# UNITED STATES PATENT AND TRADEMARK OFFICE

APPLICATION NO.	FILING DATE	FIRST NAMED INVENTOR	ATTORNEY DOCKET NO.	CONFIRMATION NO.
10/670,448	09/25/2003	Carl F. Dadson	038190/269365	5530

## Office Action Summary

## DETAILED ACTION

**FIG. 4**

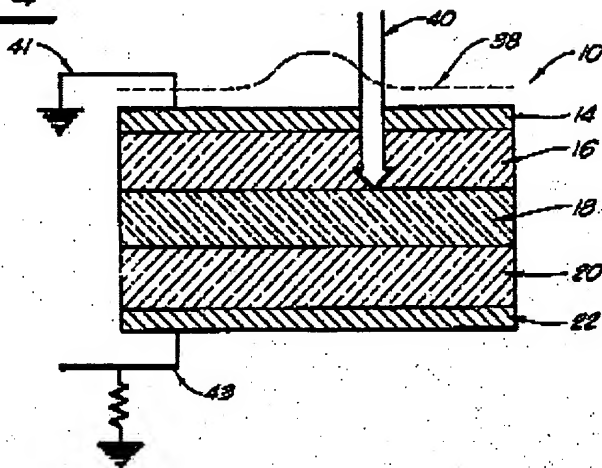
**Regarding claim 2**, Modisette discloses in Figure 4, a solid-state laser light source (see Fig. 4 Character 40, Column Lines 4 – 5, the reference call “Helium-Cadmium laser” this type of laser is a solid state laser).

**Regarding claim 5**, Modisette discloses in Figure 4, a target plate (see Fig. 4, Character 10) with a transparent heat sink layer (see Fig. 4, Character 14) facing a scanner (layer is a heat sink because it is metallic), an insulator layer (see Fig. 4, Character 16) adjacent the transparent heat sink layer, and an emissive layer (see Fig. 4, Character 18) that is at least opaque and adjacent to the insulator layer (layer is emissive because it supports a current density).

**Regarding claim 7**, Modisette discloses in Figure 4, an insulator layer of heat-resistant glass (Column. 6, Lines 41-43).

**Regarding claim 8**, Modisette discloses in Figure 4, an emissive layer comprising carbon (Column 8, Line 16).

**Regarding claim 14**, Modisette discloses since the layer (see Fig. 4, Character 14) is metallic, it acts as a heat sink that draws heat out of the target plate after scanning the laser light across the target plate to prevent the laser light from heating portions of the target plate other than the portion on which the laser light is incident.

**FIG. 6**

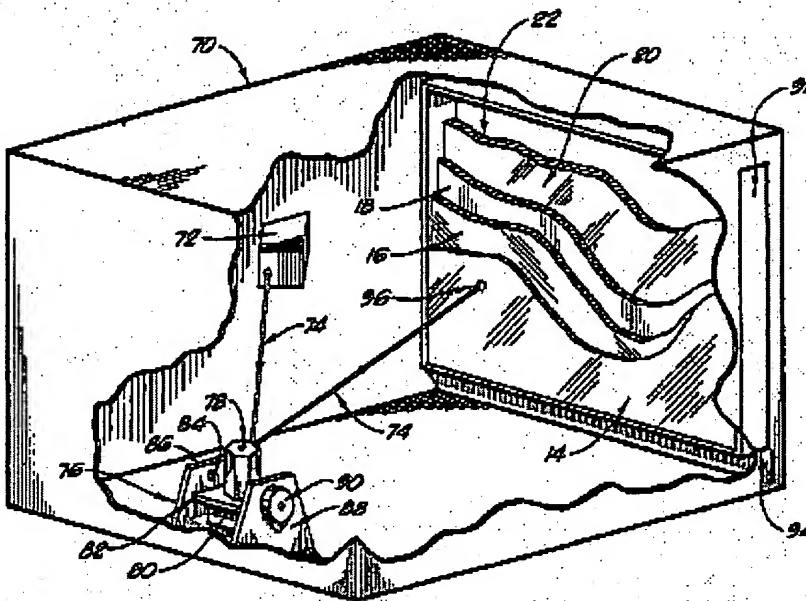
***Regarding claims 1 and 11***, Modisette discloses in Figure 6, a laser light source (see Fig. 6 Character 72), a scanner (see Fig. 6, Character 76) that receives laser light from the laser light source and redirects the laser light, a processor that controls operation of the scanner to generate an infrared image (Column 12, Lines 56-61), and a target plate (see Fig. 6, Character 92) having a first side that receives the redirected laser light (see Fig. 6, Character 74) from the scanner and second side, opposite the first side, that displays at least one infrared image having portion at different respective temperature (Column 4, Lines 46 – 50).

applicant arguments since the prior art does teach infrared image on a second side of the target plate opposite the side across which laser light has been scanned. Modisette '985 show in Figure 6, the laser light (74) was scanned by (76) and is well known in the art the infrared image on a second side of the target plate opposite the side across which laser light has been scanned (column 12, lines 20 – 61) as stated in the rejection above.
